The Town of Hilton Head Island Regular Design Review Board Meeting

Tuesday, January 11, 2011

Town of Hilton Head Island
DESIGN REVIEW BOARD
Minutes of the Tuesday, December 14, 2010 Meeting
1:15pm – Benjamin M. Racusin Council Chambers

DESIGN TEAM/ DRB COMMENT SHEET

PERMIT SET A-6

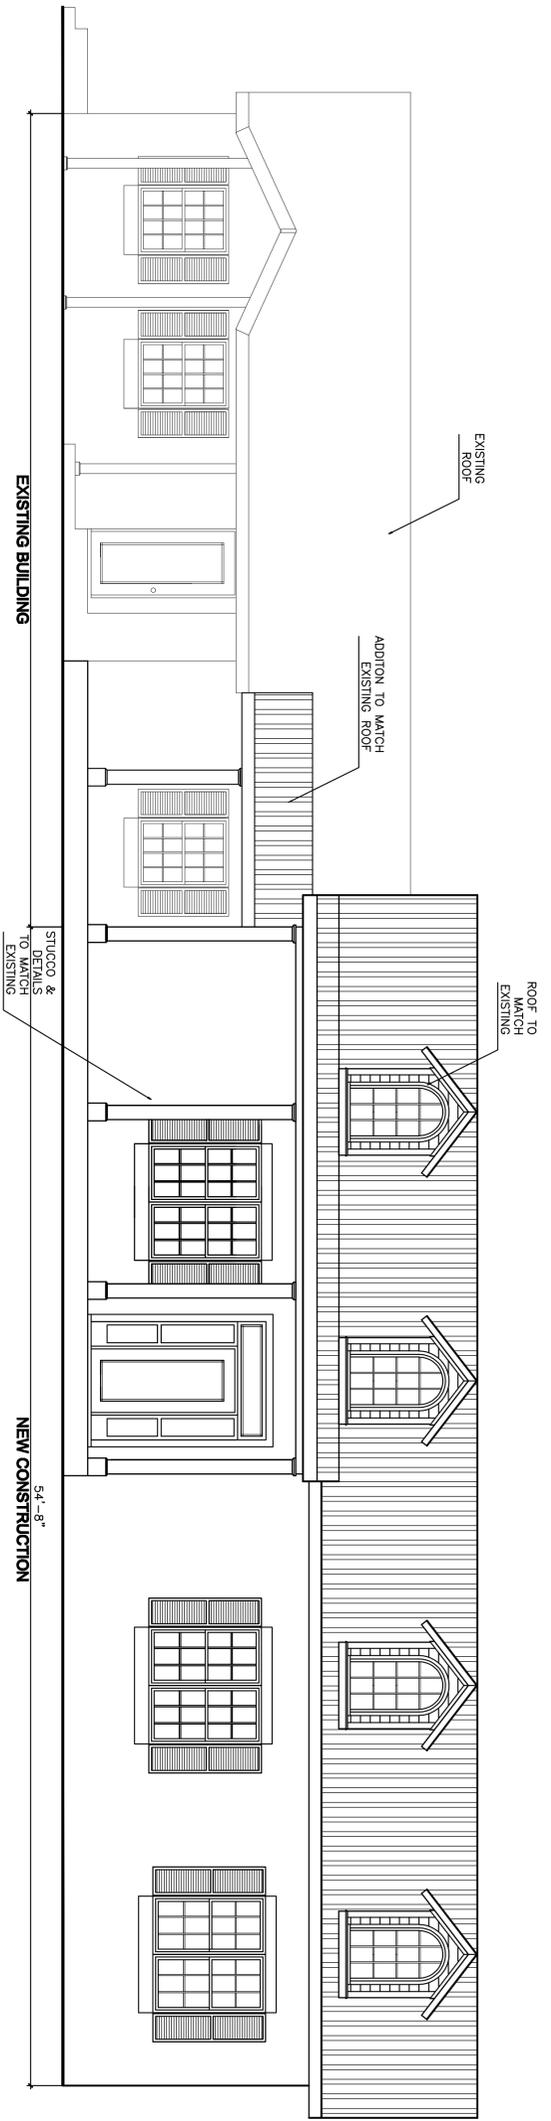
ARCHITECTURAL DESIGN
 The approvable elements remain (colors, materials, etc.), and improvements have been made in regards to the Board’s concerns regarding consistency in some aspects (i.e windows, shutter details) and better integrating the addition into the existing 900 SF building. The “Bank as Bookends” approach has been abandoned. The project elements not directly addressed by the Design Guide can be clarified by the Board and applicant at the next meeting. An updated site plan will be required, as well as an updated landscape plan

DATE
DECEMBER 28, 2010
PROJECT NUMBER
01-10013
SHEET TITLE
Planting Plan & DETAILS

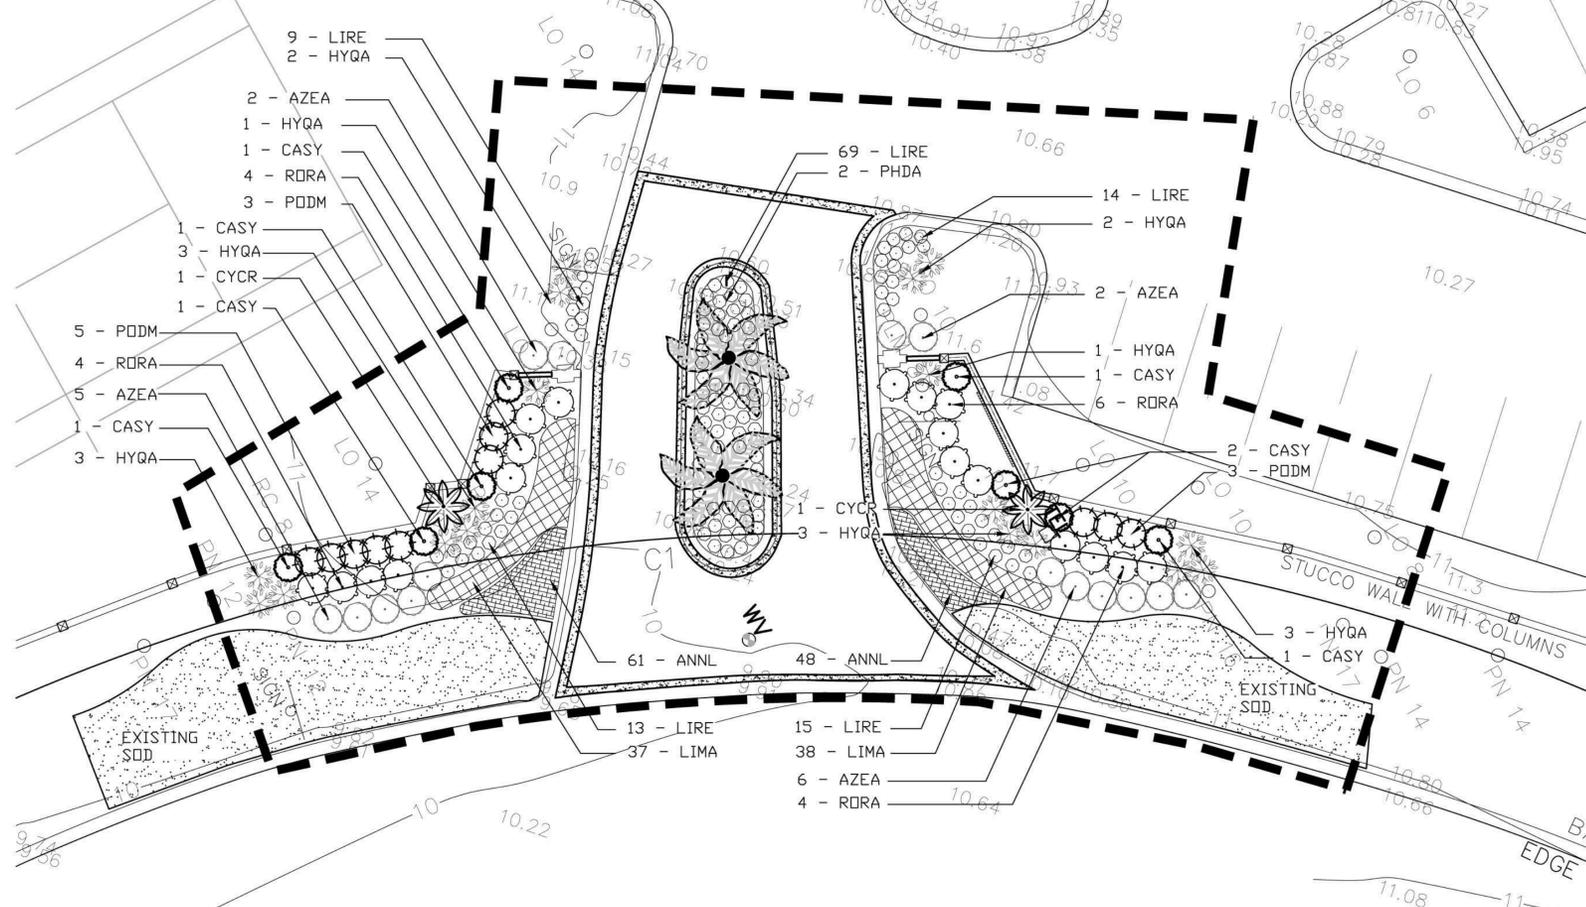
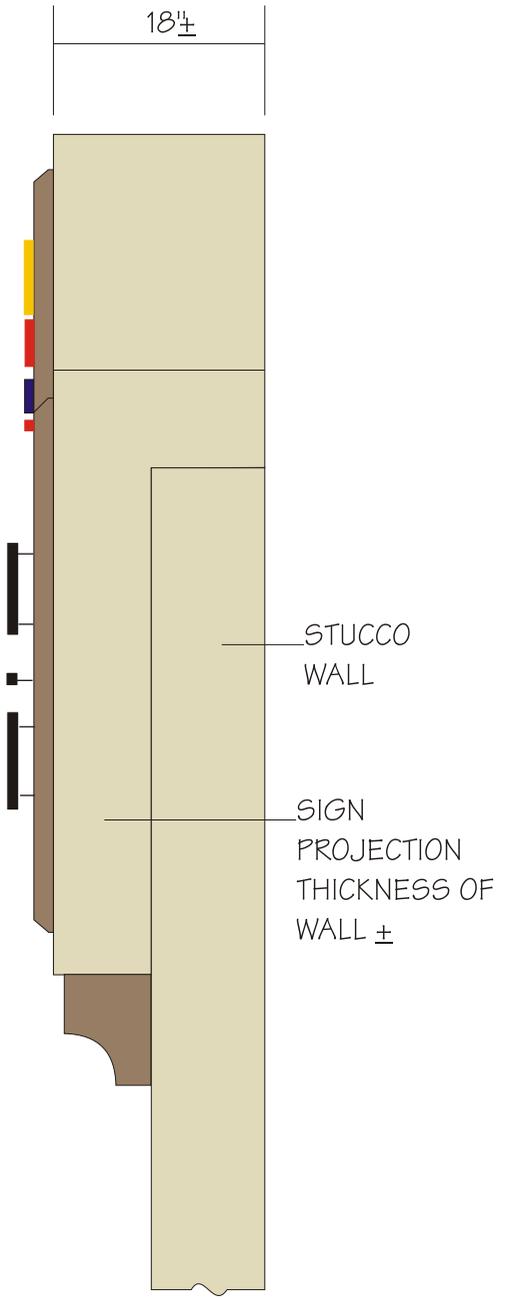
Provides overall order and continuity of the Landscape plan	Y	
Native plants or plants that have historically been prevalent on the Island are utilized	Y/N	Some elements are relatively ornamental, but appropriate as an entry feature. See "limited to entrances and focal points" below
A variety of sizes is selected to create a "layered" appearance for visual interest and a sense of depth	Y	
The location of existing mature trees is taken into account in placement of shrubs so as not to damage tree roots	Y	
Proper spacing and location for plants to reach their mature size and natural shape while avoiding	Y

Park Plaza Shell Renovation

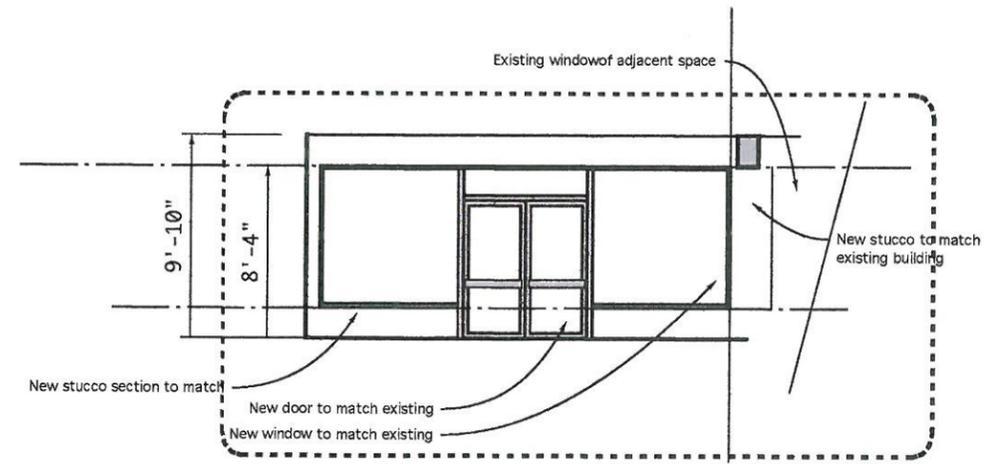
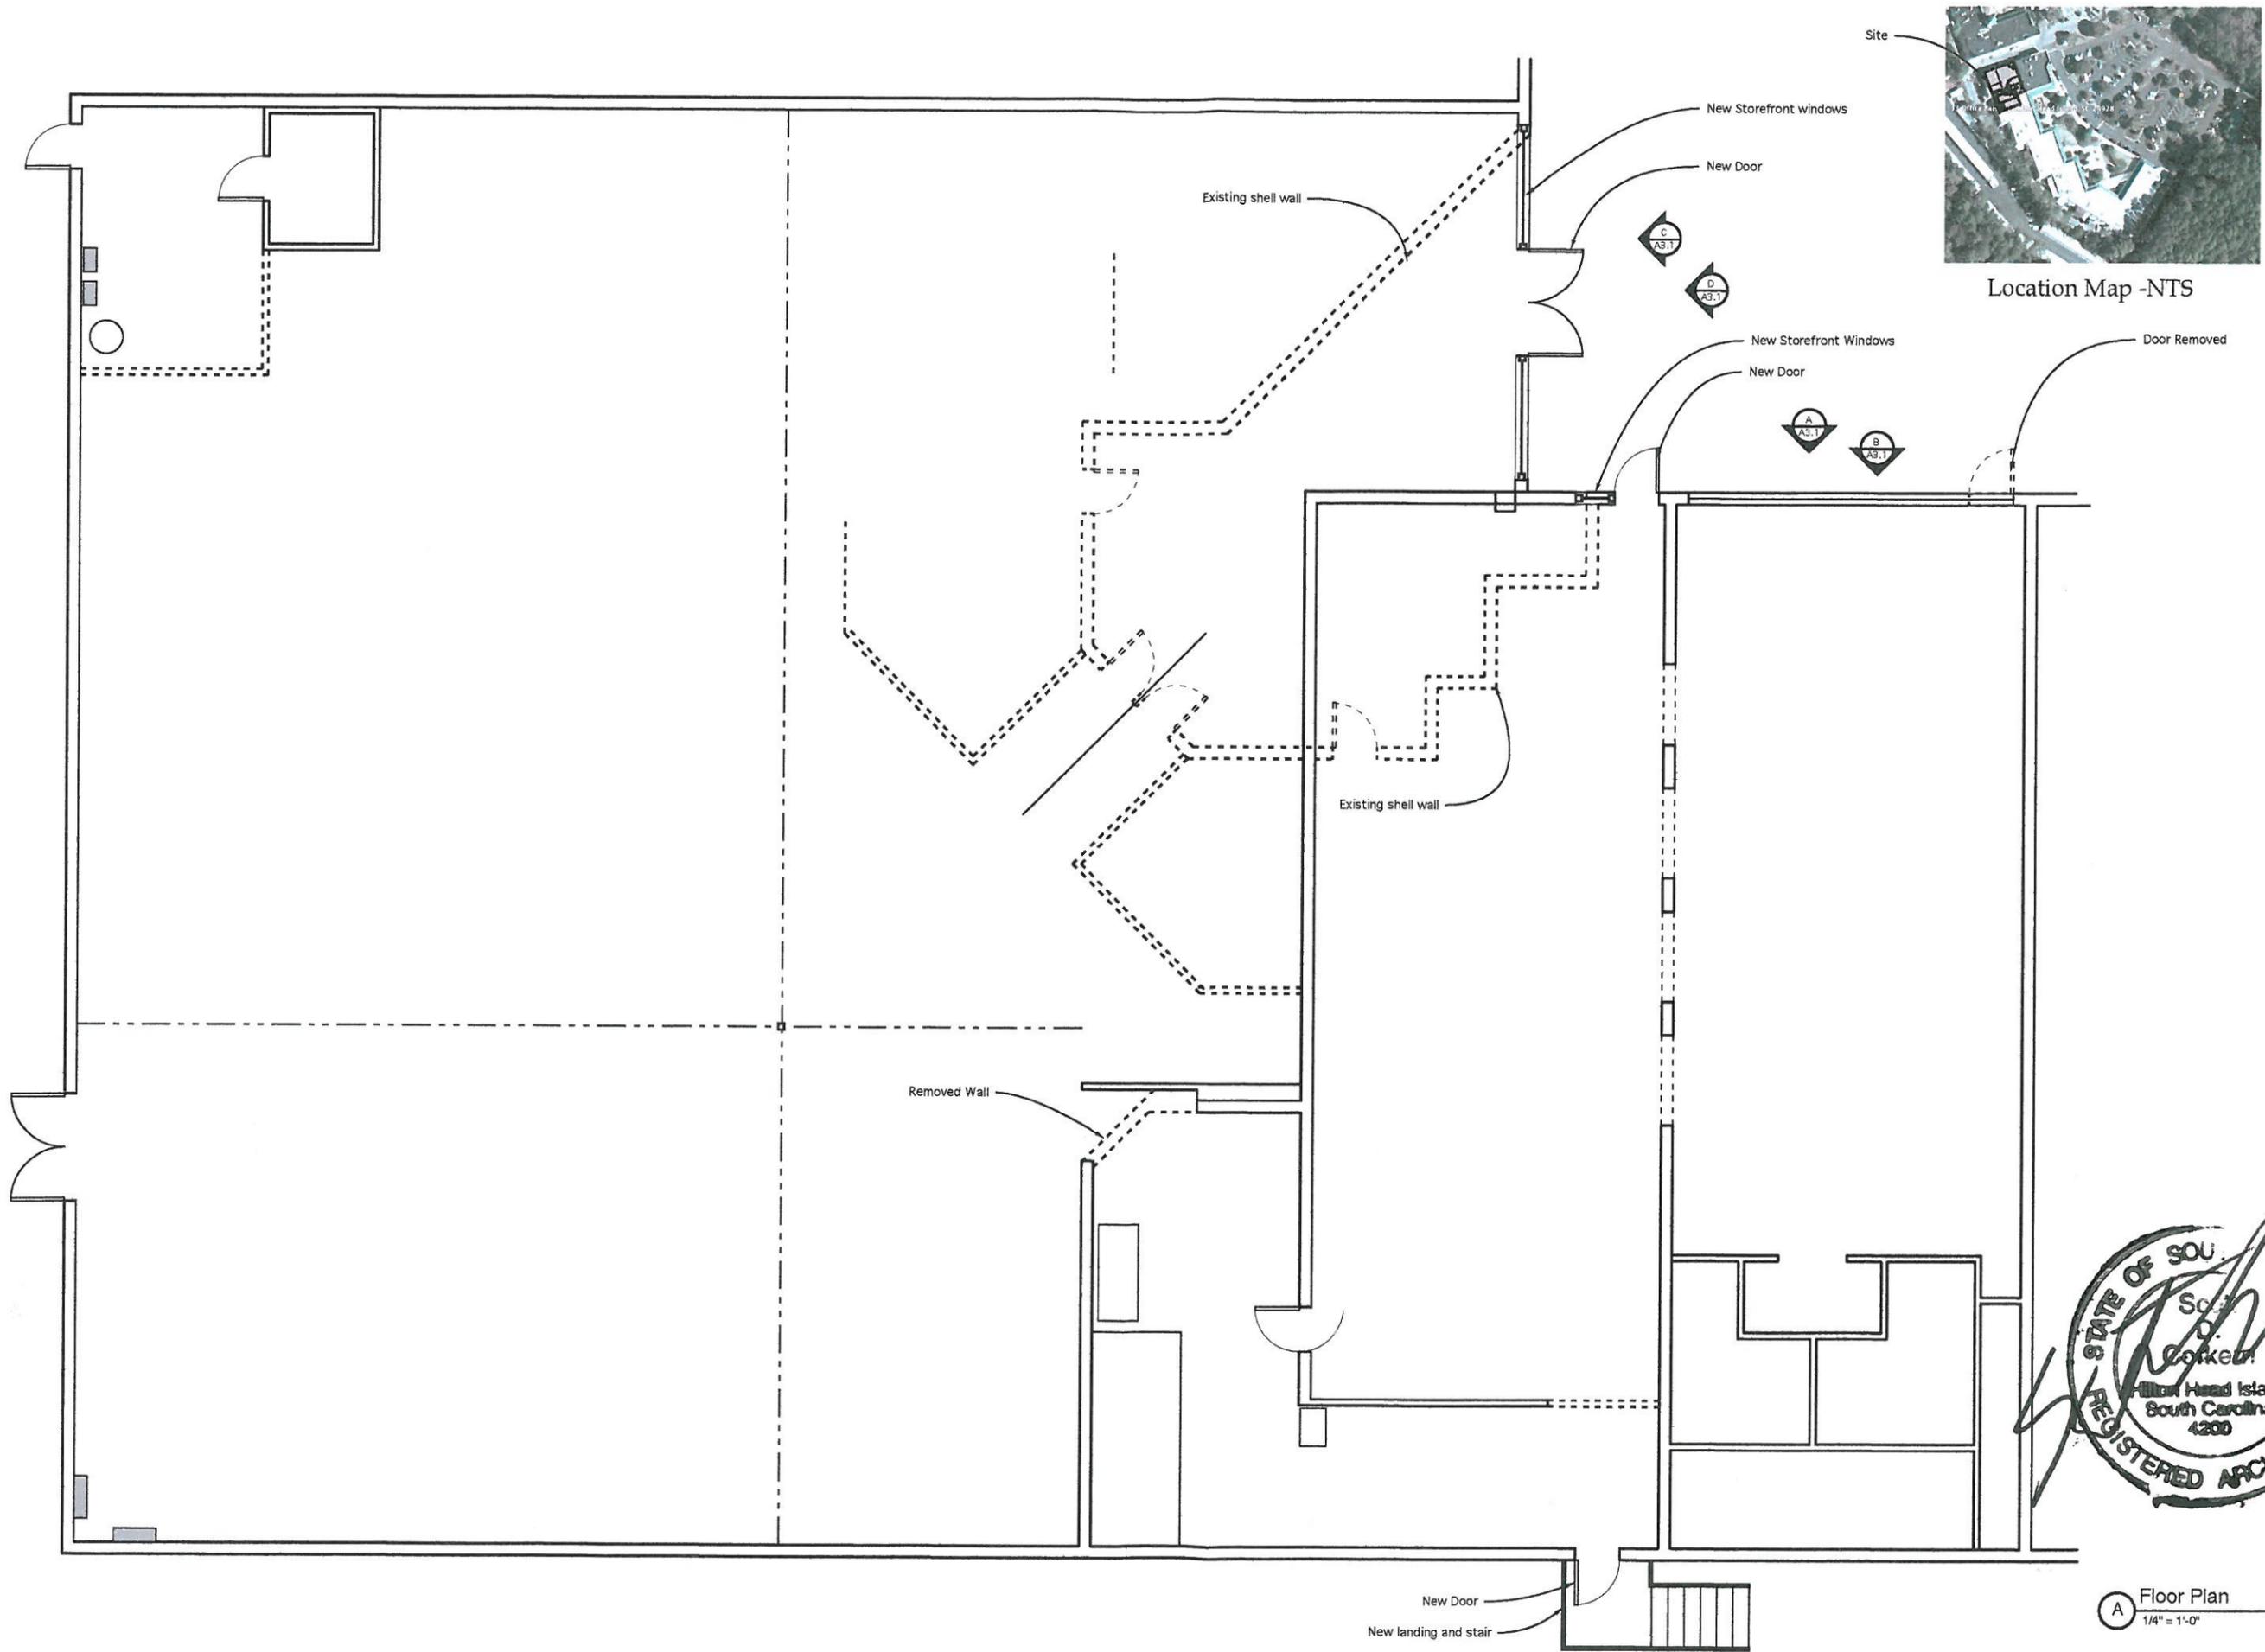
ARCHITECTURAL DESIGN		
A reconfiguration and installation of a new storefront system to the two old tenant spaces. Materials and colors to match		
DESIGN GUIDE/LMO CRITERIA	COMPLIES YES/NO/N/A	COMMENTS OR CONDITIONS
Structure is designed to be appropriate to the neighborhood		
Promotes pedestrian scale and circulation		
Design is unobtrusive and set into the natural environment		
Utilizes natural materials and colors		
Avoids distinctive vernacular styles		
Design is appropriate for its use		
All facades are have equal design characteristics		
Avoids monotonous planes or unrelieved repetition		
Has a strong roof form with enough variety to provide visual interest		
Minimum roof pitch of 6/12		
Overhangs are sufficient for the façade height.		
Forms an details are sufficient to reduce the mass of the structure		
Human scale is achieved by the use of proper proportions and architectural elements		
Utilizes a variety of materials, textures and colors
